A Report Prepared for

Van Waters & Rogers Inc.  
6100 Carillon Point  
Kirkland, Washington 98033

SOIL BORING  
SAMPLING AND ANALYSIS PLAN  
PRELIMINARY STUDY AREA ORDER  
BOISE, IDAHO

August 13, 1993

**Proposed Boring/Well Locations**  
Soil Boring Sampling and Analysis Plan  
Boise, Idaho

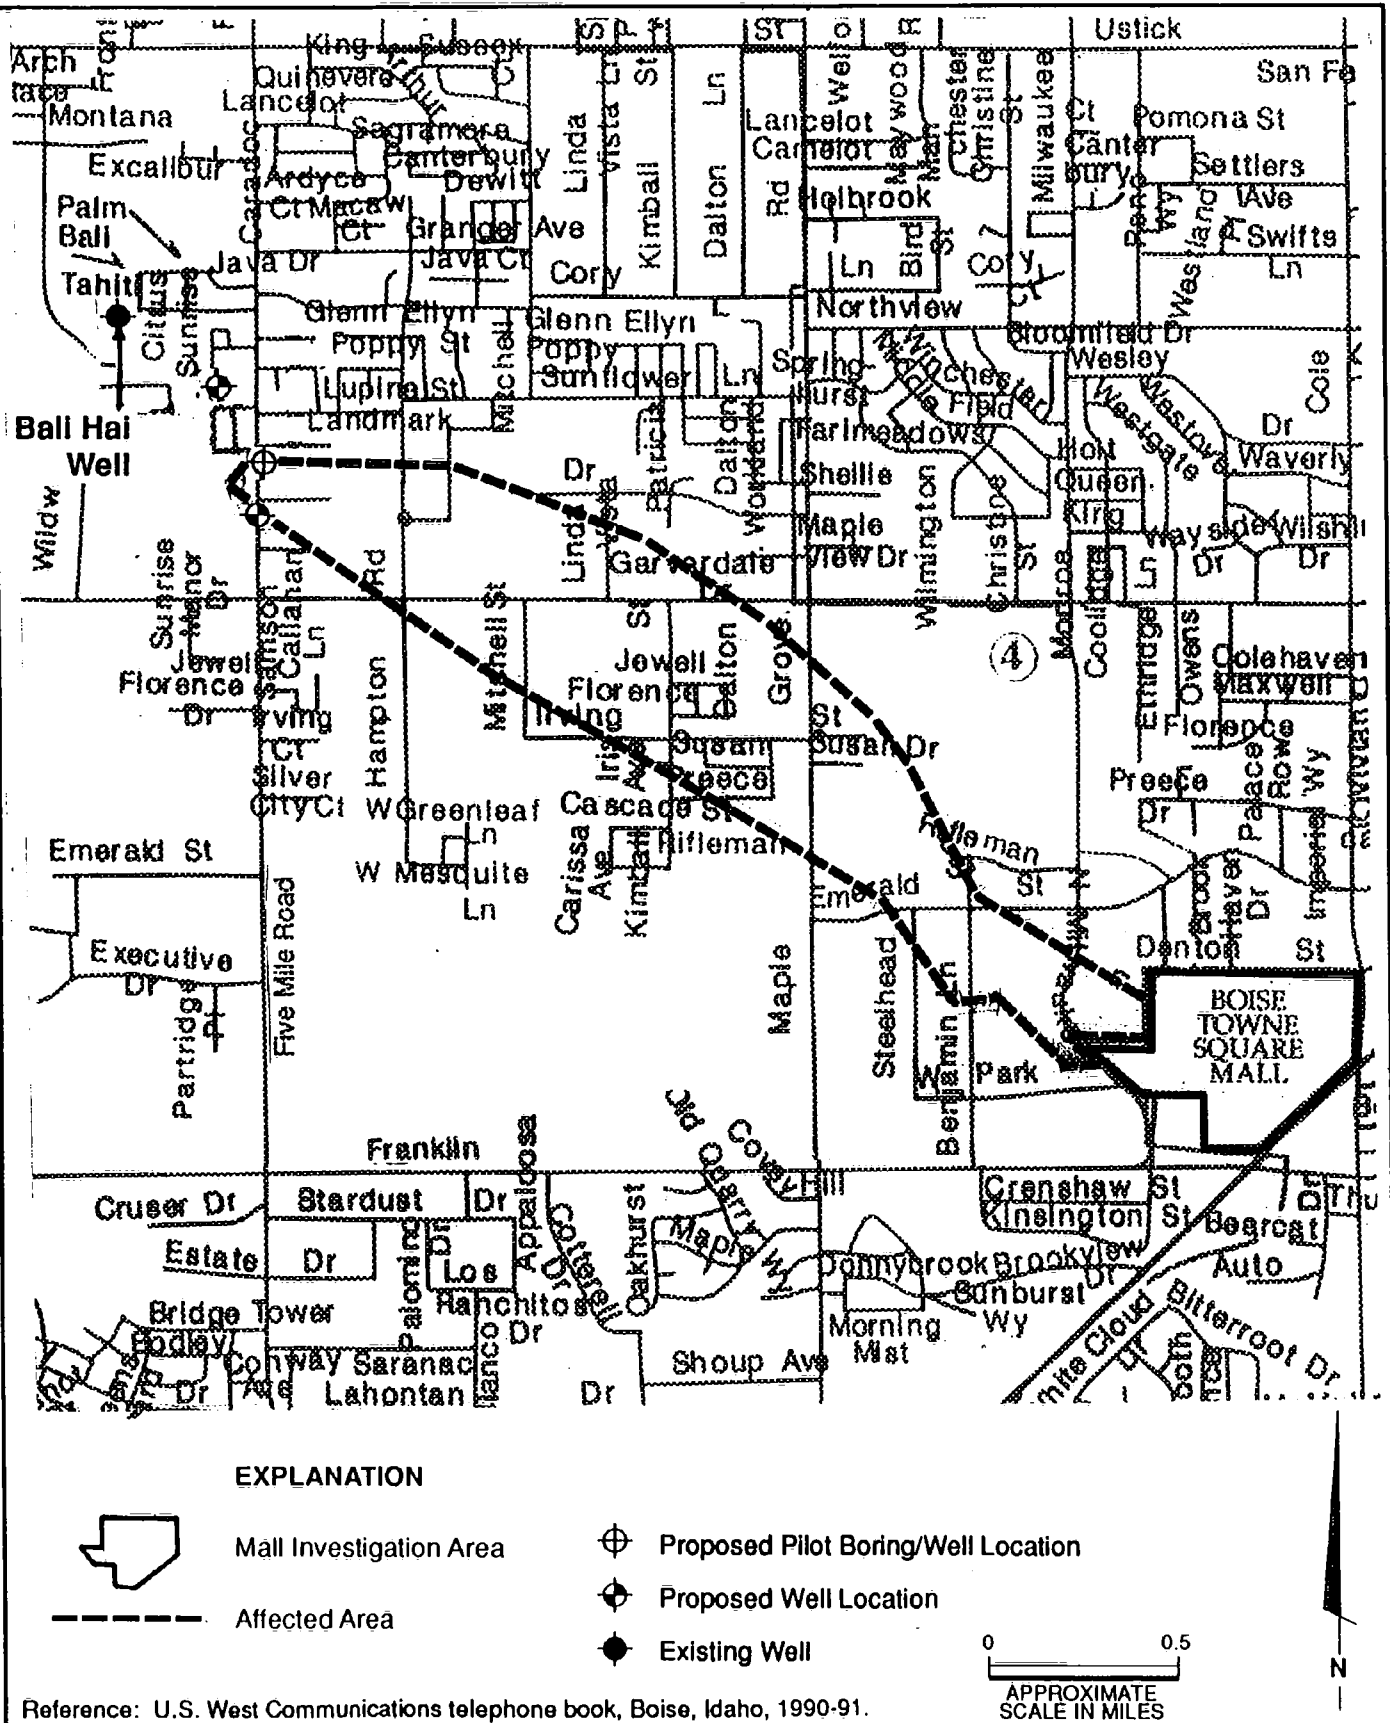
We request that you amend your drilling plan to allow the northwestern-most monitoring well to be completed at the depth of the first screened interval of the Bali Hai community well. We will not require that the monitoring well be completed at this depth if a significant confining unit is encountered at a shallower depth. We believe that this change in the drilling plan will provide a greater security through early detection of contaminants approaching the Bali Hai well.

VW&R shares the DEQ's concern for protection of water quality downgradient of the Affected Area, particularly in the vicinity of the Bali Hai community well. Installation of a monitoring well between the Affected Area and the Bali Hai well is an important component of any protection strategy; however, based on available data, we believe that a deep monitoring well is not warranted.

We have reviewed the well log for the Bali Hai well and have determined that the uppermost screened interval is from 347 feet to 356 feet below ground surface. Geophysical data for the well also indicates sandy gravel comprises the upper 40 feet of the borehole, followed by approximately 95 feet of silty sand. Beneath the silty sand, at a depth of approximately 135 feet and extending to a depth of 210 feet, is a "blue" clay. Alternating layers of sand, silty sand, and clay are found at depths greater than 210 feet. The thicknesses of the sand and silty sand layers range from approximately 20 feet to 50 feet; the thicknesses of the clay layers range from approximately 20 feet to 120 feet. The Bali Hai well is screened in the sand and silty sand layers.

Surface geophysical data collected from the horse pasture at 1941 Five Mile Road during the pilot boring program indicated the presence of significant reflectors typical of a clay layer at an approximate depth of 150 feet. This significant reflector likely corresponds to the blue clay noted on the Bali Hai well log. This layer, as well as deeper clay layers encountered during the drilling of the Bali Hai well, would be expected to inhibit downward flow of ground water under non-pumping conditions, and potentially under pumping conditions.

VW&R proposes that the influence, if any, pumping of the Bali Hai well has on the shallow aquifer be evaluated and appropriate action be implemented based on the results of the evaluation. To evaluate what effect pumping of the Bali Hai well has on the shallow aquifer, a monitoring well will be installed as described in the Soil Sampling and Analysis Plan. A data logger and transducer will be utilized to provide a record of water levels within the well. Water levels will be monitored during one pumping period (i.e., summer) and the three month period following cessation of pumping. In addition, two existing domestic wells will be added to the list of wells that are sampled each quarter. These include a 100-foot deep well located at the LDS church on Five Mile Road and a 269-foot well located at the distal end of the Affected Area. Data collected during the August 1992 sampling event indicated perc was not detected in either of the ground water samples collected from these wells.

The construction details for the guard well described in the Soil Sampling and Analysis Plan for the Preliminary Study Area will be revised such that a four-inch diameter monitoring well will be constructed. The final depth of the well and the screened interval will be determined in the field based on results of chemical profiling. Grab water samples will be collected at ten foot intervals during the drilling of the borehole and analyzed for VOCs utilizing EPA Method 8010. These samples will be submitted to Alchem Laboratories in Boise for expedited analysis.
